**Date of Issue:** May 2014

**Affected Publication:** API Specification 8C, *Drilling and Production Hoisting Equipment (PSL 1 and PSL 2)*, Fifth Edition, April 2012

## ERRATA

**Figure 7—Sheave Grooves**

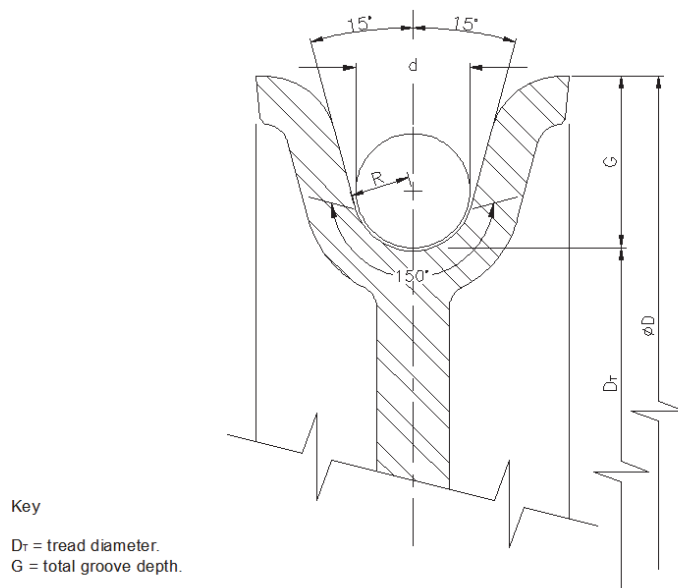
Page 29, Figure 7 shall be replaced with the following:

Page 29, Section 9.2.5, the first two sentences of the first paragraph shall read:

Grooves for sand-line sheaves shall be made for the selected rope size. The bottom of the groove shall have a radius of between  $R_{min}$  and  $R_{max}$  [see Equation (10) and Equation (11)] subtending an arc of 150 degrees.
